AGENDA
PARKS, RECREATION & NATURAL RESOURCES COMMITTEE
MEETING

To: Planning Commission
From: Frank Dempsey, AICP, Associate Planner
Date: July 12, 2024
Subject: Packet Material for the July 18, 2024 Planning Commission Meeting

Ryan Sailer, representing Timberland Partners, Inc. has submitted applications and plans for a preliminary plat, final plat, and conditional use permit for Sundance Lakeville Second Addition, which proposes one lot and one block with 13 townhome buildings and 167 dwelling units and nine single family home lots with rental homes all totaling 15.75 acres north of 162nd Street (CSAH 46), west of Buck Hill Road and east of Kendale Avenue.

SUNDANCE LAKEVILLE

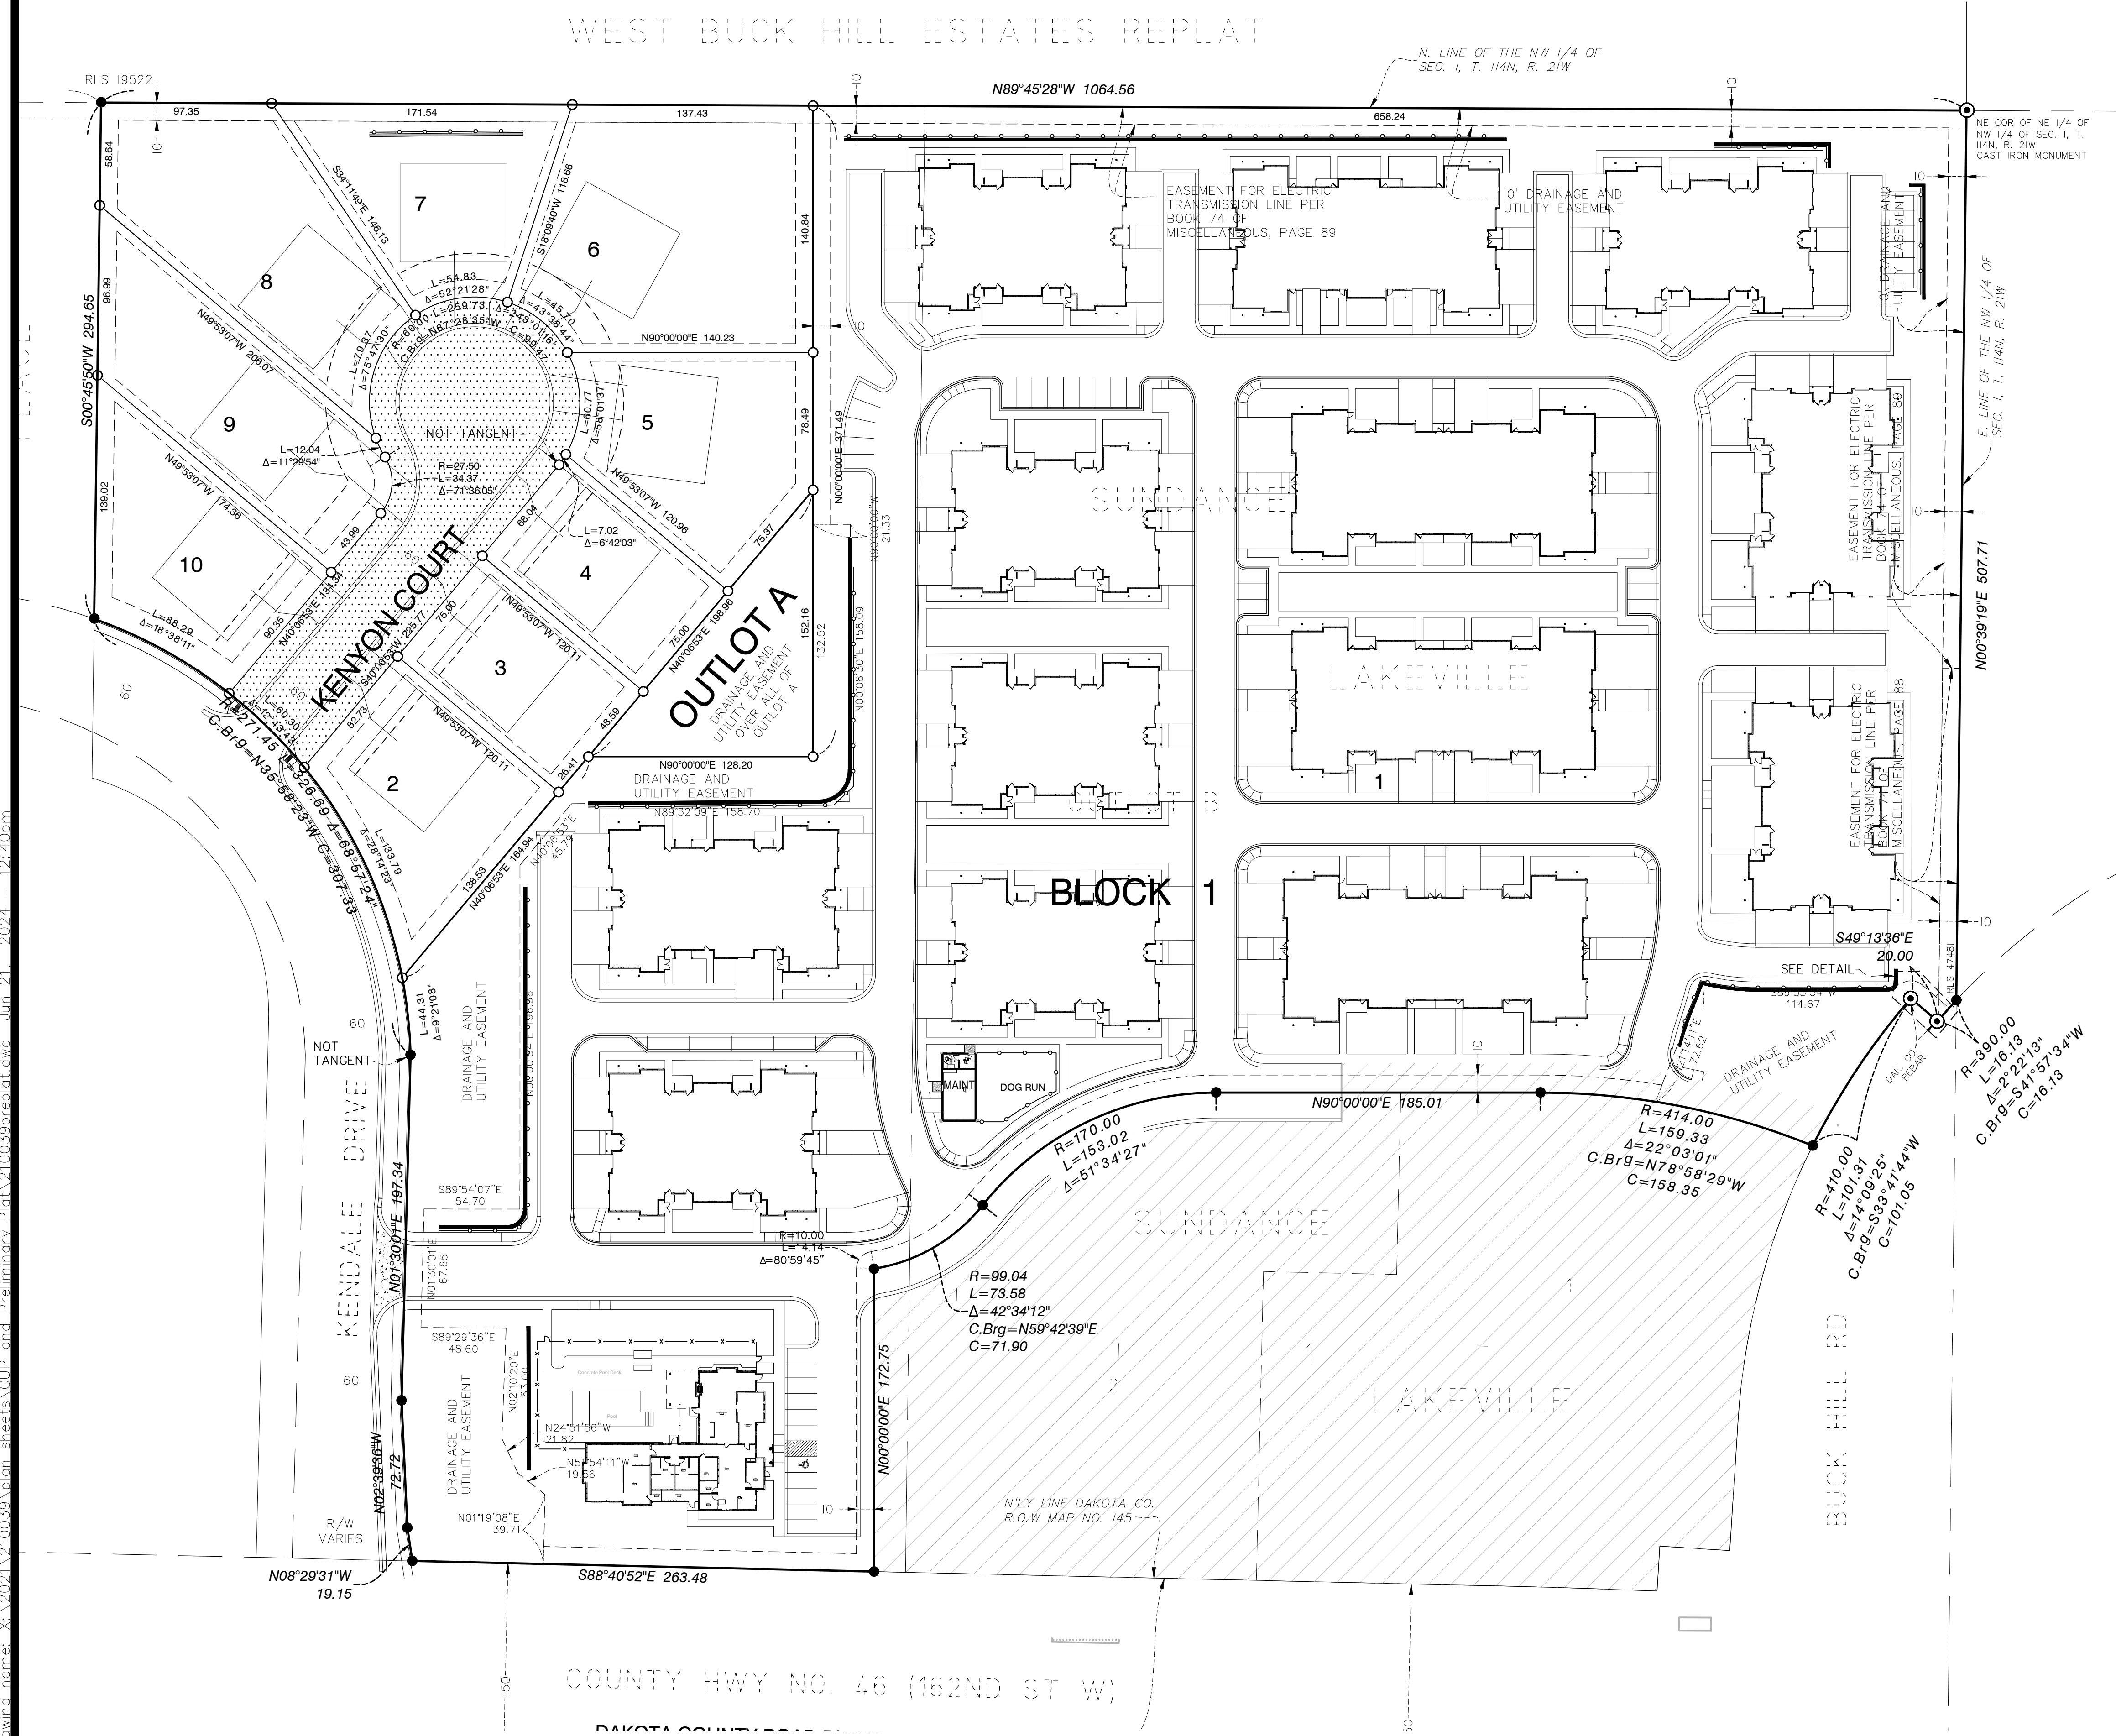
RST-2	Minimum Lot Width and Lot Area	Lots 2-9
Lot Width	Corner 85 ft. Interior 70 ft.	Lots 2 and 4 shall be revised for lot width prior to approval of the preliminary plat
Lot Area	Corner 10,500 ft. Interior 8,400 ft.	All lots comply with minimum area requirements

The lots comply with minimum lot area and lot width requirements except for Lot 2 and 4 which do not clearly determine lot width at the 20 foot garage setback line. The preliminary plat shall be revised to demonstrate compliance with minimum lot width prior to City Council consideration of the preliminary plat.
